Form 3160-5  
(June 2019)UNITED STATES  
DEPARTMENT OF THE INTERIOR  
BUREAU OF LAND MANAGEMENTFORM APPROVED  
OMB No. 1004-0137  
Expires: October 31, 2021**SUNDRY NOTICES AND REPORTS ON WELLS**  
**Do not use this form for proposals to drill or to re-enter an abandoned well. Use Form 3160-3 (APD) for such proposals.**

8. Well Name and No. HAWK 35 FED/304H

EOG respectfully requests an amendment to our approved APD for this well to reflect the following changes:

Hawk 35 Fed 512H (FKA 304H) API #: 30-025-48085

## WELL LOCATION AND ACREAGE DEDICATION PLAT

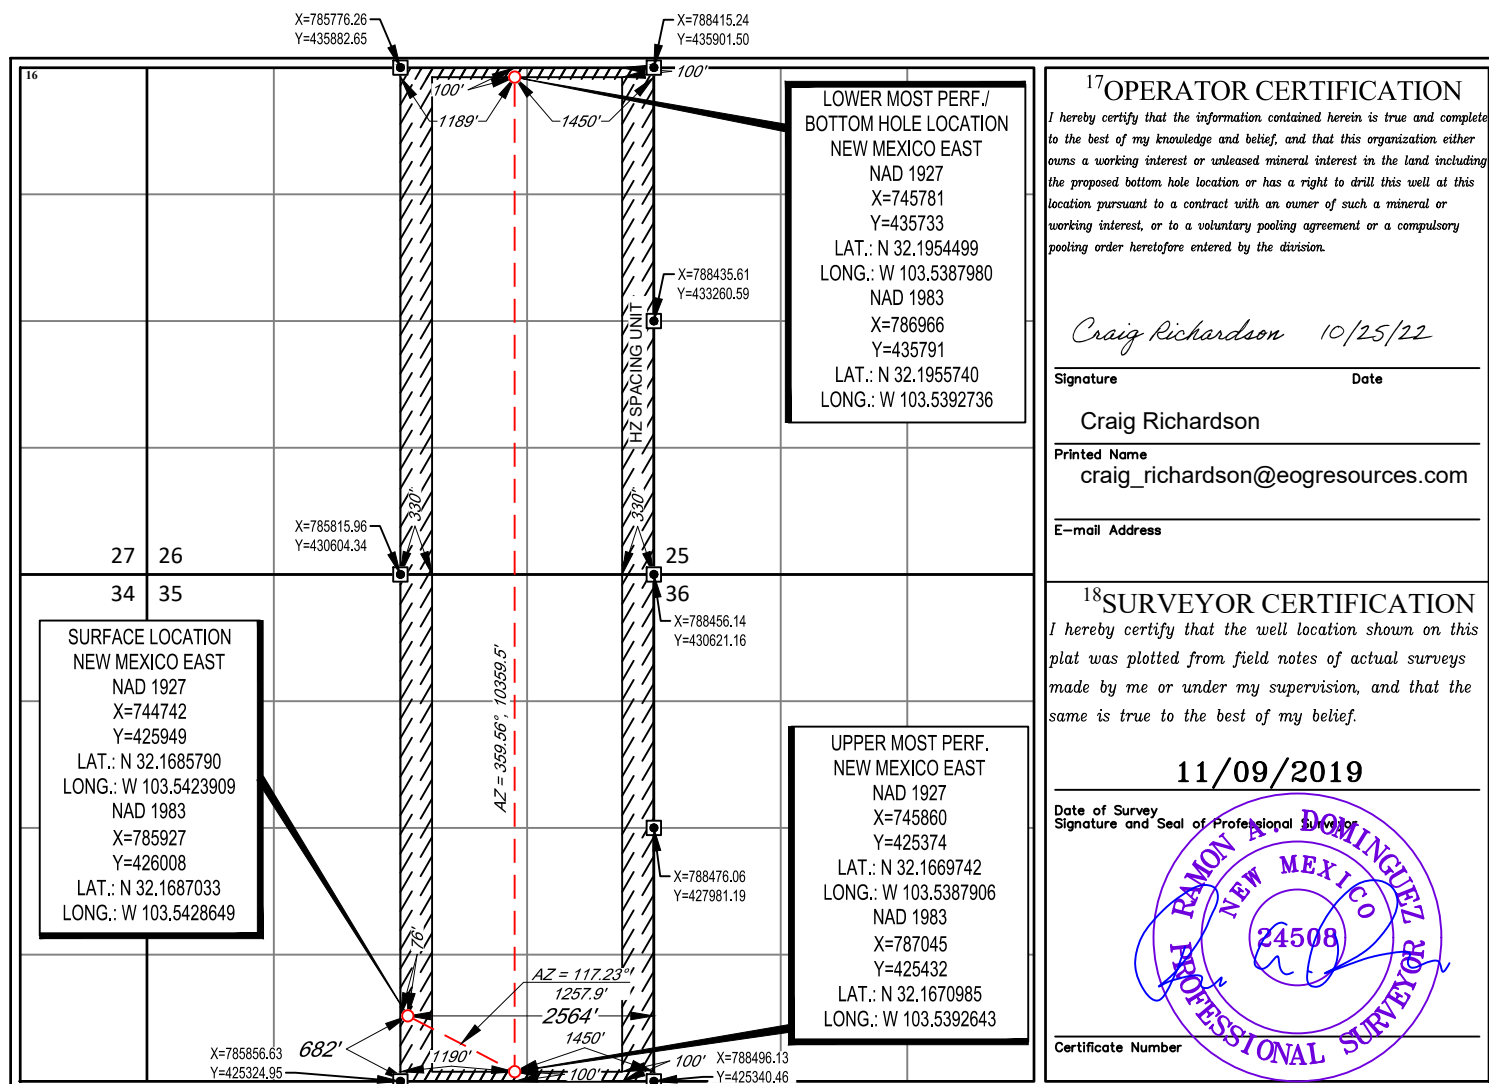
Change name from Hawk 35 Fed 304H to Hawk 35 Fed 512H.

Change SHL from T-24-S, R-33-E, Sec 35, 742' FSL, 2459' FEL, Lea Co., NM, to T-24-S, R-33-E, Sec 35, 682' FSL, 2564' FEL, Lea Co., N.M.

Change BHL from T-24-S, R-33-E, Sec 26, 100' FNL, 2330' FWL, Lea Co., NM, to T-24-S, R-33-E, Sec 26, 100' FNL, 1450' FEL, Lea Co., N.M.

UL or lot no.	Section	Township	Range	Lot Idn	Feet from the	North/South line	Feet from the	East/West line	County
0	35	24-S	33-E	—	682'	SOUTH	2564'	EAST	LEA

UL or lot no.	Section	Township	Range	Lot Idn	Feet from the	North/South line	Feet from the	East/West line	County
B	26	24-S	33-E	—	100'	NORTH	1450'	EAST	LEA

Hawk 35 Fed #512H

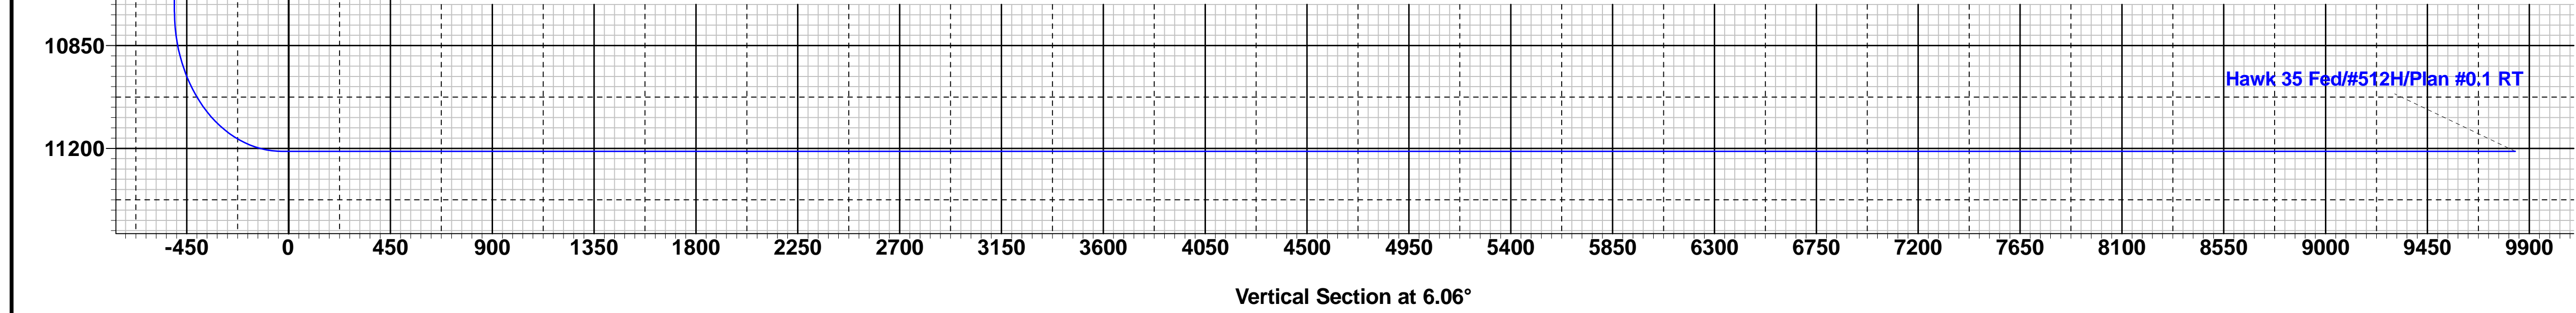
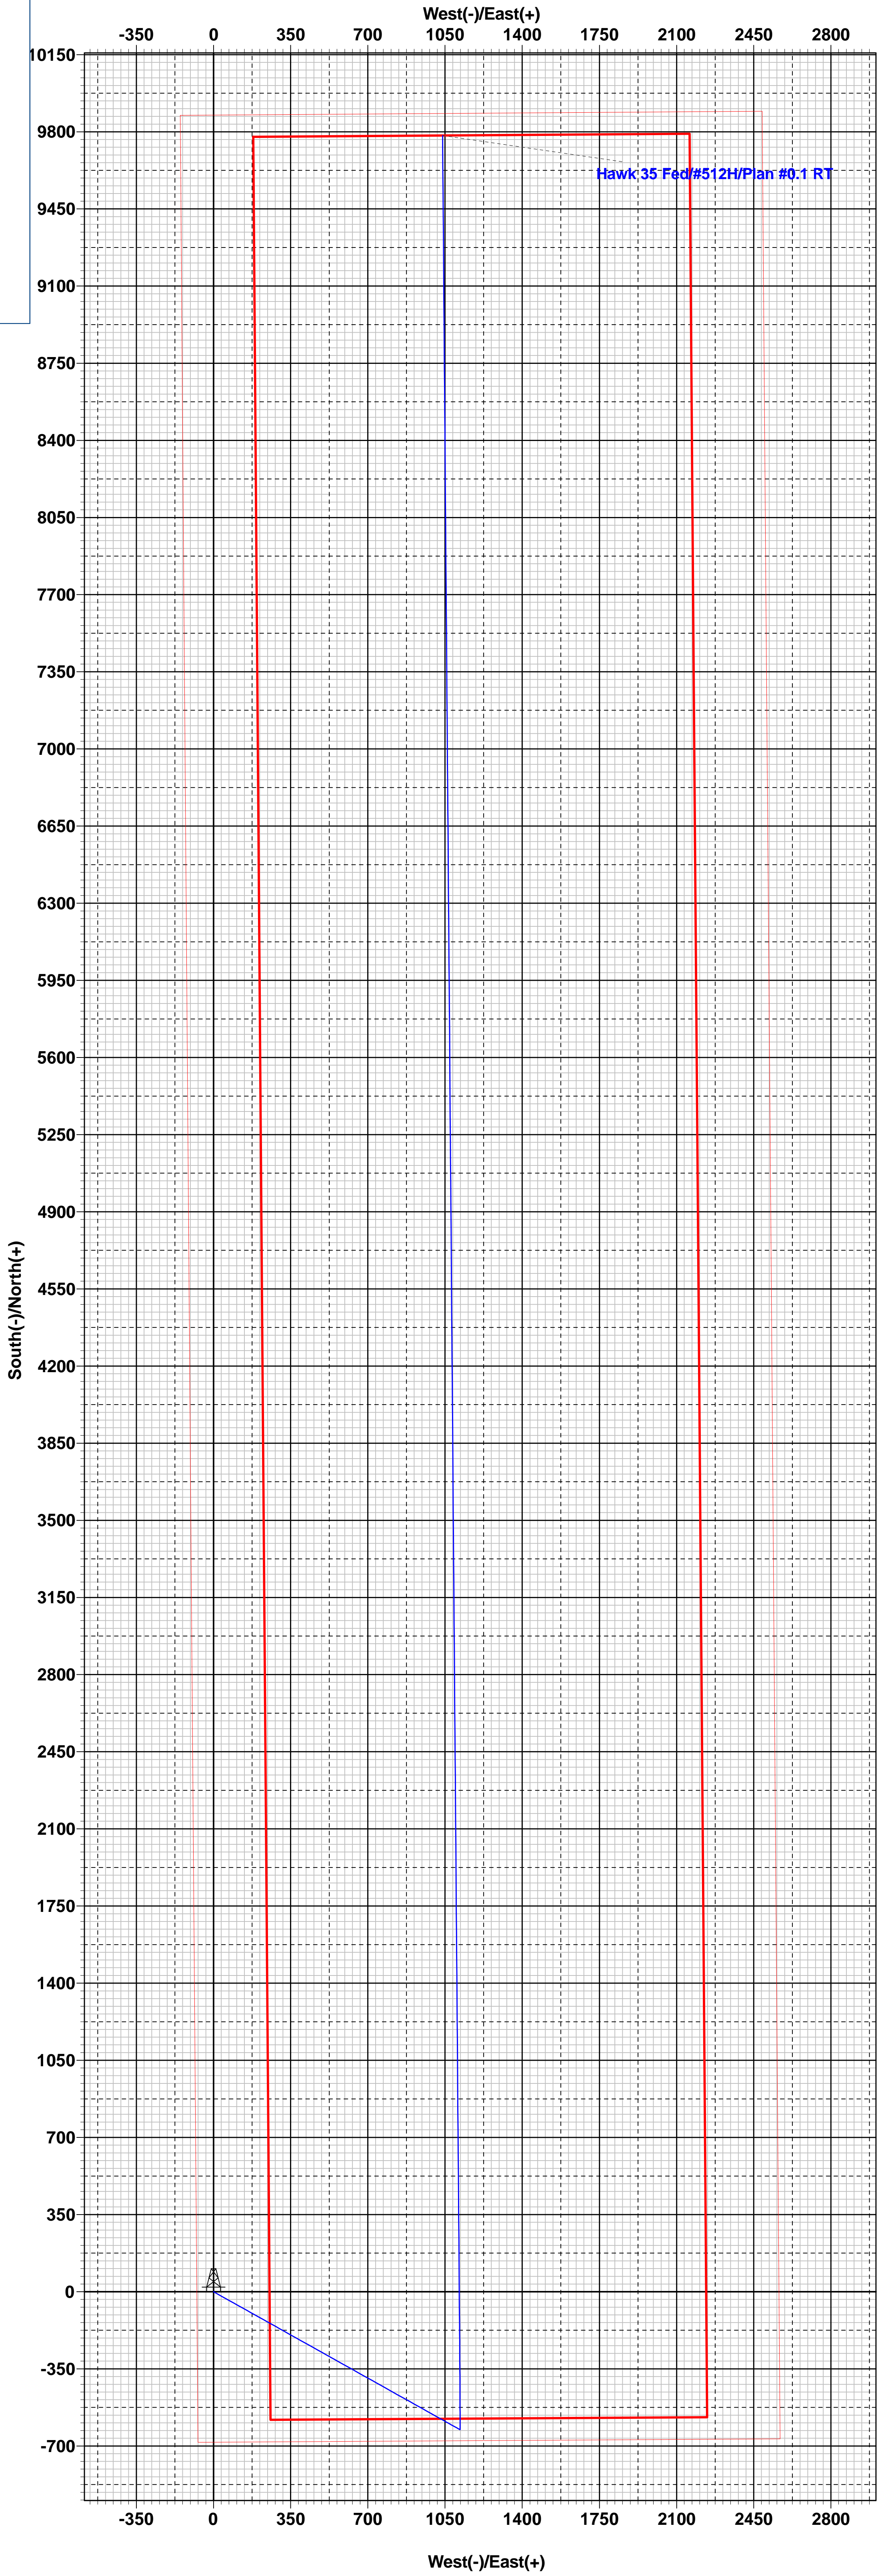
Change target formation to Second Bone Spring Sand.

WELL DETAILS: #512H			
kb = 26' @ 3534.0usft			
3508.0			
Northing	Easting	Latitude	Longitude
426008.00	785927.00	32.1687045°N	103.5428647°W

SECTION DETAILS										
Sec	MD	Inc	Azi	TVD	+N/-S	+E/-W	Dleg	TFace	VSect	Target
1	0.0	0.00	0.00	0.0	0.0	0.0	0.00	0.00	0.0	
2	1400.0	0.00	0.00	1400.0	0.0	0.0	0.00	0.00	0.0	
3	2029.3	12.59	119.25	2024.2	-33.6	60.1	2.00	119.25	-27.1	
4	7277.9	12.59	119.25	7146.8	-592.4	1057.9	0.00	0.00	-477.3	
5	7907.2	0.00	0.00	7771.0	-626.0	1118.0	2.00	180.00	-504.4	
6	10868.7	0.00	0.00	10732.5	-626.0	1118.0	0.00	0.00	-504.4	KOP(Hawk 35 Fed #512H)
7	11089.2	26.46	0.00	10945.2	-576.0	1118.0	12.00	0.00	-454.7	FTP(Hawk 35 Fed #512H)
8	11618.7	90.00	359.56	11209.9	-148.5	1115.7	12.00	-0.49	-29.9	
9	21550.5	90.00	359.56	11210.0	9783.0	1039.0	0.00	0.00	9838.0	PBHL(Hawk 35 Fed #512H)
